**City Planning Commission
Meeting – March 24, 2015**

**CONSIDERATION – SUBDIVISION DOCKET – 013/15
Applicants: Camille M. Lemann & Mathilde M. Lemann**

Proposal: Resubdivision of Lot 1 into Lots 1A, 1B and 1C.

A Resubdivision of Lot 1 (Lot 7 Tax Rolls) Into Lots 1A, 1B & 1C.

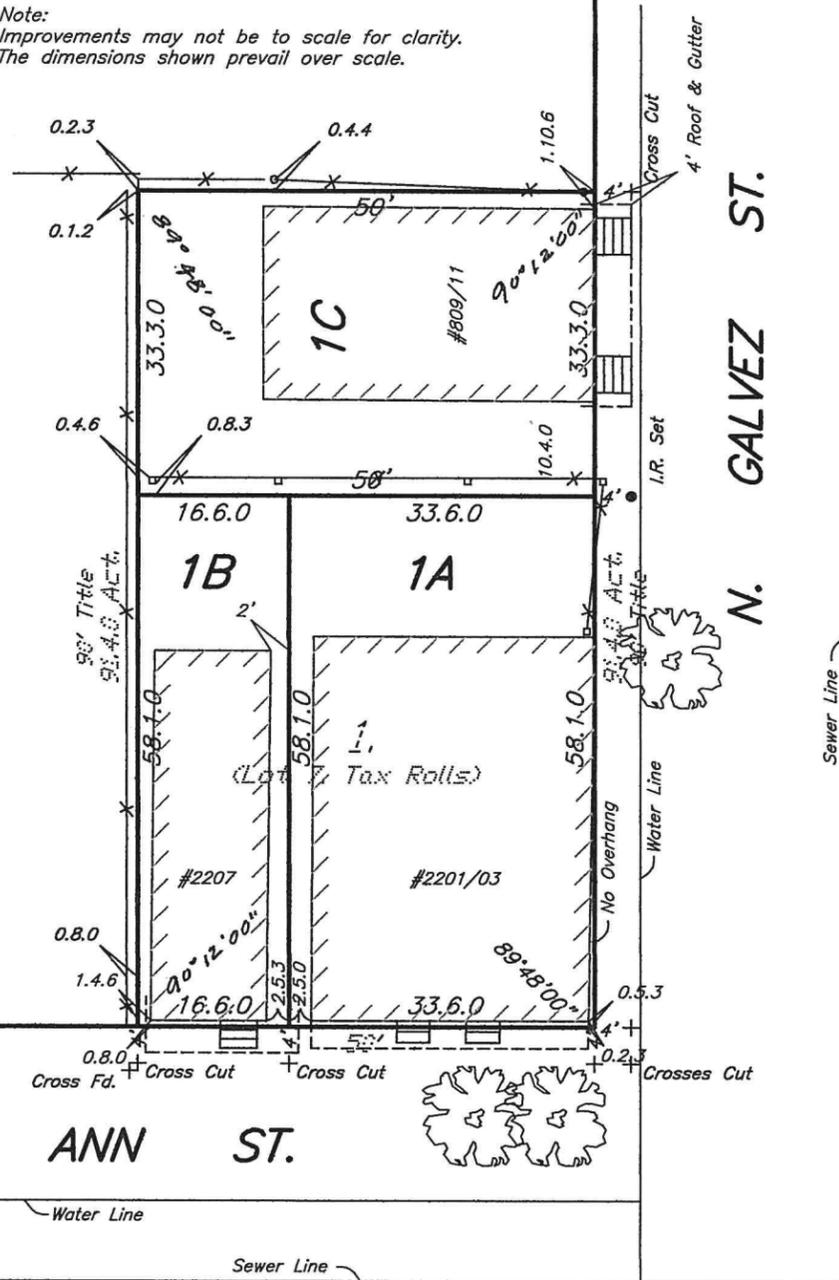
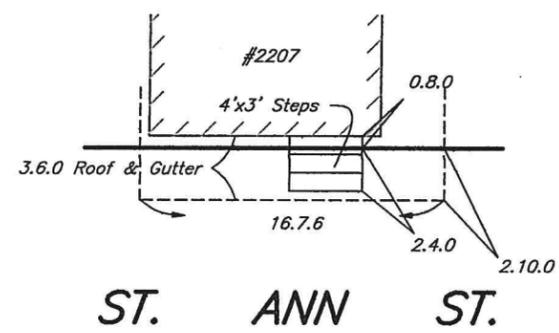
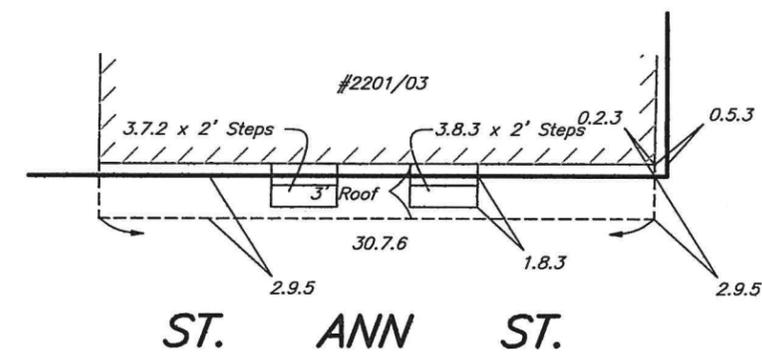
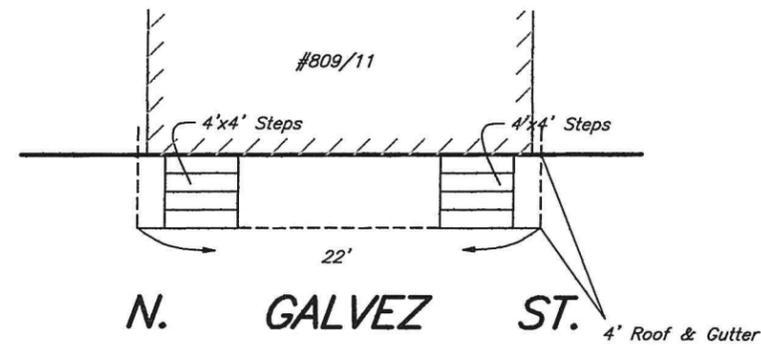
The Department of Property Management, Division of Real Estate and Records noted no objection to the proposal, finding no exceptions regarding ownership and the survey. However, they noted that servitude agreements were needed for stair and roof encroachments into the public right-of-way.

The representative of the Sewerage and Water Board stated that subsurface drainage was available. They also noted that sewer and water facilities are available but not shown on the survey, and recommended that a note should be on the subdivision plans stating that sewer and water house connections are the responsibility of the property owner.

The Department of Safety and Permits noted an objection to the proposal since the addition of a lot line between the buildings located on Proposed

Lots 1A and 1B would create a deficiency related to the building code. A minimum of three (3') feet is required between new lot lines and structures. Each structure would be located approximately two (2'-5") feet five inches from the proposed side lot line, and a waiver from the Board of Building Standards and Appeals would be necessitated.

The proposed lot line between Proposed Lots 1A and 1B is optimally placed as it would maximize the side yard width available between the two properties. However, as there is only approximately five (5') feet between the two existing properties, and a minimum of six (6') feet is required per the building code and zoning code, a resubdivision would require the applicant to rectify the deficiency with the Board of Building Standards and Appeals.

The proposed property line separating Proposed Lots 1A and 1B from Proposed Lot 1C would enable the construction of a parking space on this lot. Currently, no property provides off-street parking, and thus these deficiencies are grandfathered. The proposed lot line, however, would cause the properties on Proposed Lots 1A and 1B to provide insufficient rear yard depth. A waiver of approximately five (5') feet would be necessitated by each. This proposed property line could be adjusted seven (7') feet to eliminate or lessen the waiver necessary. At the same time, this adjustment would allow the property on Proposed Lot 1C to meet the minimum interior side yard requirement of three (3') feet.

The staff recommends **tentative approval** of Subdivision Docket 013/15, with final approval subject to three (3) waivers and four (4) provisos.

1. The applicant shall secure a Board of Building Standards and Appeals (BBSA) waiver for structures within three feet (3') of the newly created property line.
2. The applicant shall comply with any requirements deemed necessary by Entergy, the Sewerage and Water Board, the Departments of Public Works, the Department of Property Management, Division of Real Estate and Records, the Department of Safety and Permits, and the HDLC.
3. The applicant shall comply with all other Subdivision Regulations, which includes the submittal of mortgage certificates, a consent letter from the mortgage company (if applicable) and tax certificates for the petitioned site.
4. The applicant shall submit a reproducible copy and two (2) prints and a digital copy of the final resubdivision survey in dwg., dfx, or ESRI compatible file format.
